37/03-04UU 7220 Spruce Ave
Takoma Park Historic District

7220 Spruce - before and after (second story addition to Contributing Resource)

HISTORIC PRESERVATION COMMISSION STAFF REPORT

PROPOSAL: Construction of 2nd-story addition

DESIGN B

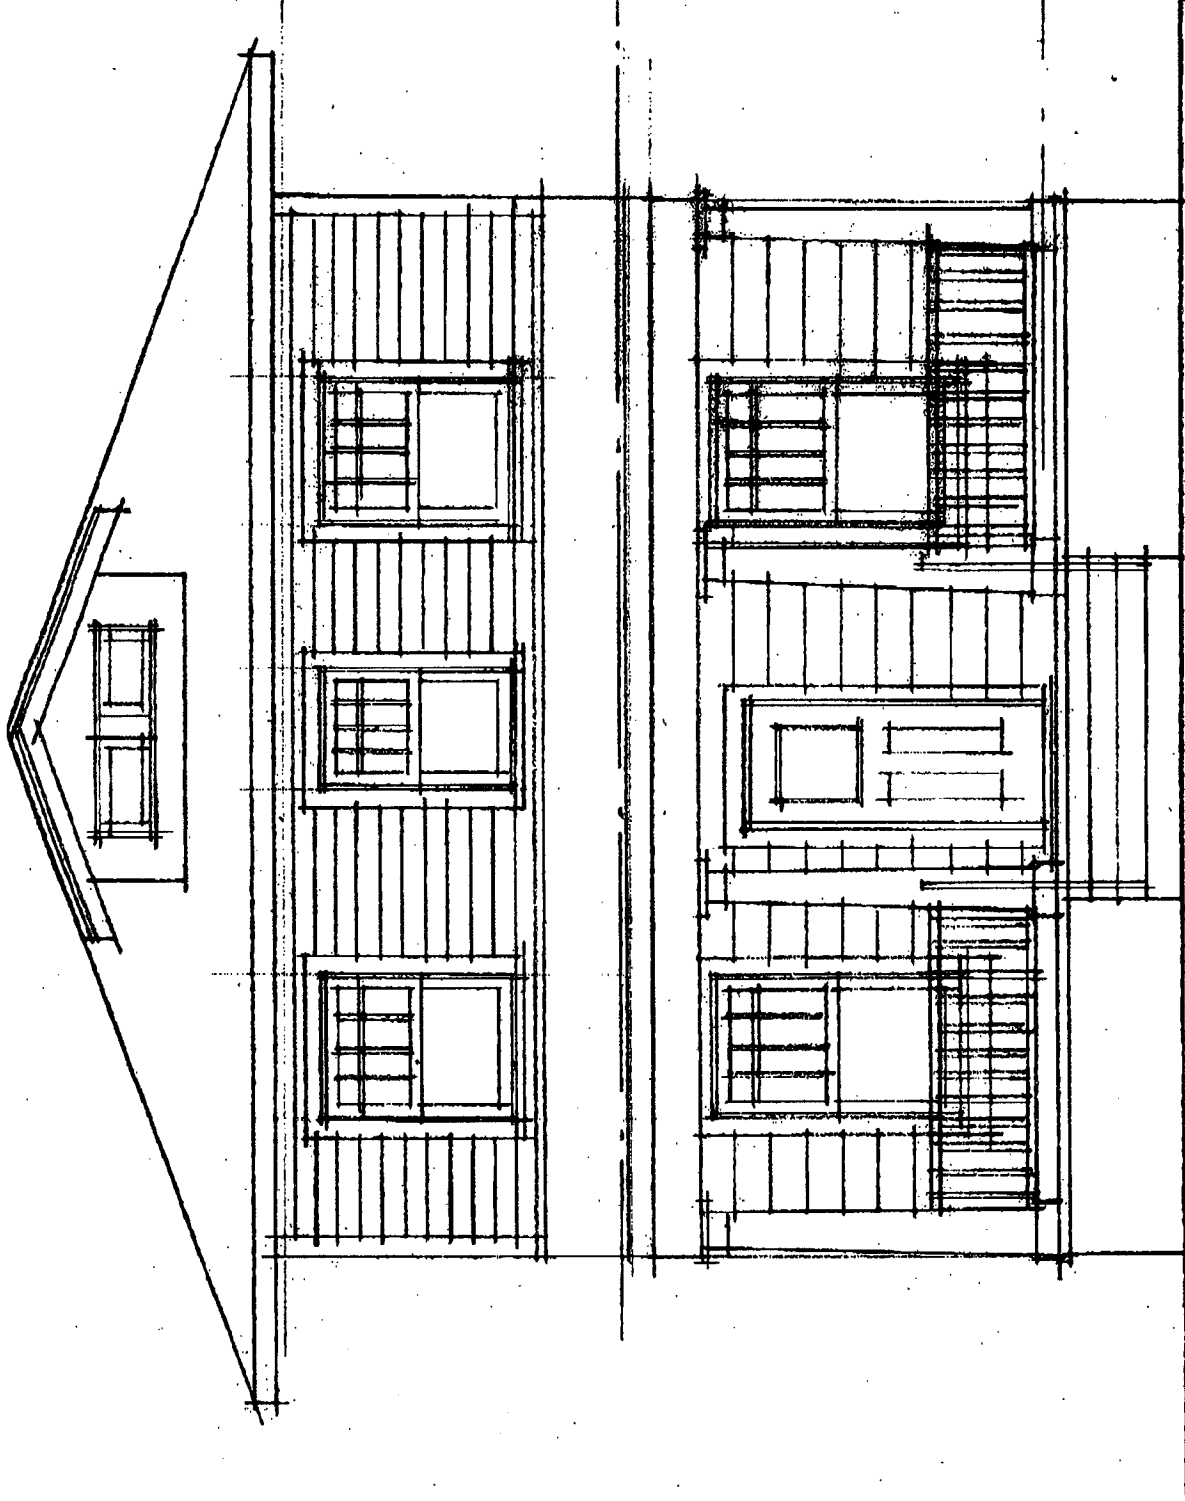
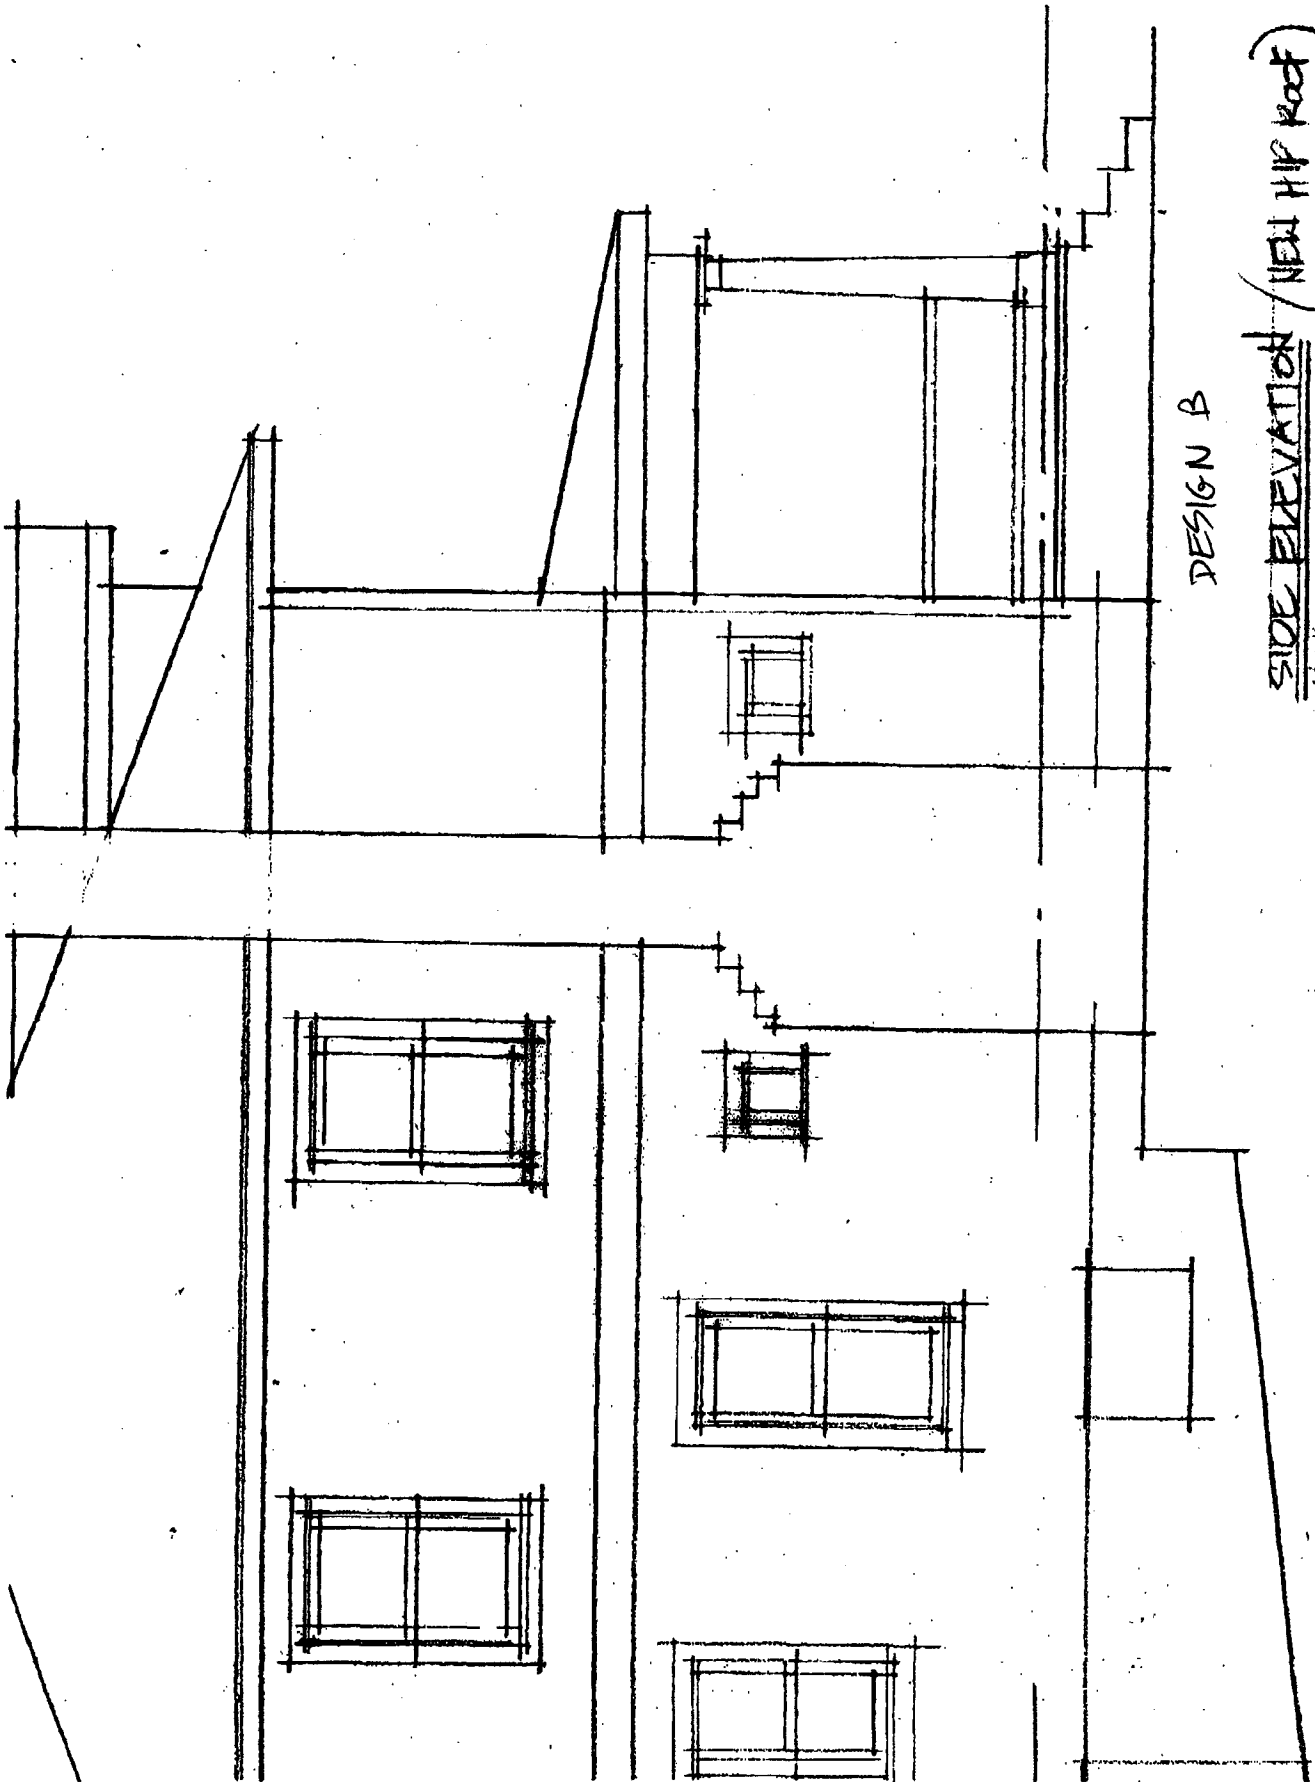
Here's the hip roof, placed on a full second floor. We could pull the roof height down some, but we'd have to change the pitch of the hip, as well as add dormers. Seems like it would be the same type of (major) change to the roof as my scheme.
